AENC-NG-CNS-REP-0236

Norwich to Tilbury

**Document: 8.3.20 Draft Statement of Common Ground - Low Carbon
Limited (Crouch Solar Farm) - Tracked Changes Version**

Planning Inspectorate Reference: EN020027

Figure 1 Interface between Crouch Solar Farm and the Project alignment

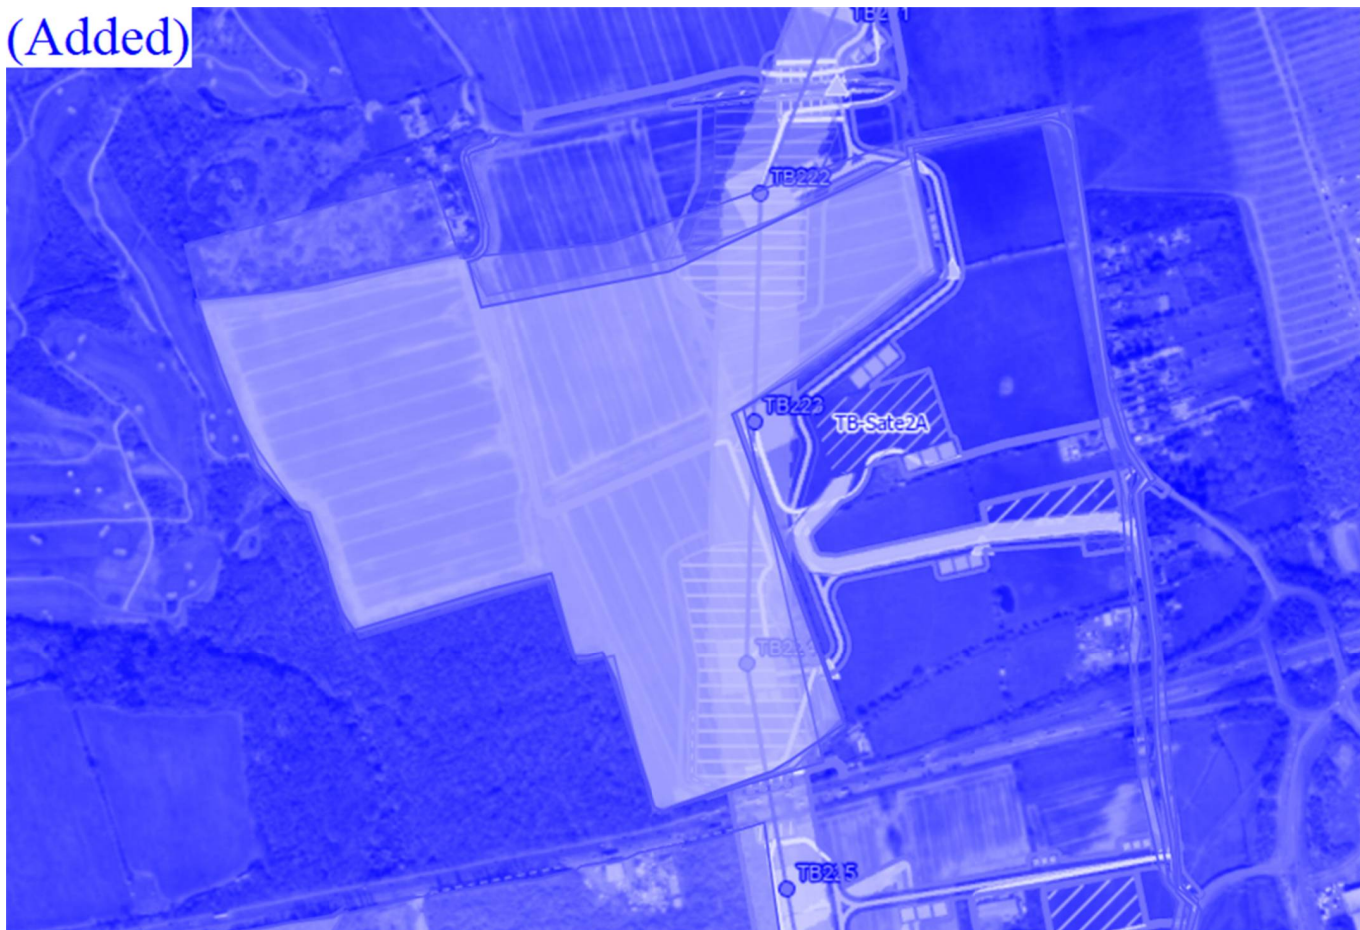
| ID | Issue | <u>National Grid Position</u> | Stakeholder position (including date) | National Grid response (including date) | Relevant documentation |
|-------------------|---------------------------------|---|---|---|------------------------|
| 6.17.1 | Location of pylons (222 to 224) | <u>The Applicant confirms that pylons TB222 to TB224 locations are progressing through detailed design. Final location to be confirmed.</u> | From Relevant Representation 27/11/25 - Low Carbon Limited seek engagement to reach agreement on the precise location of pylon nos. 222 to 224 (whether within the limits of deviation currently proposed or by modifying the limits), and on the acquisition of associated permanent rights, to seek to minimise the impact of the location of those pylons and the rights acquired under the DCO on the solar farm's operations. | 15/02/26 – National Grid and its detailed design partners will engage further with Low Carbon Limited to seek to provide further certainty on the proposed pylon locations 222 to 224 and the permanent rights of access with a view to minimising impacts as best able. | |
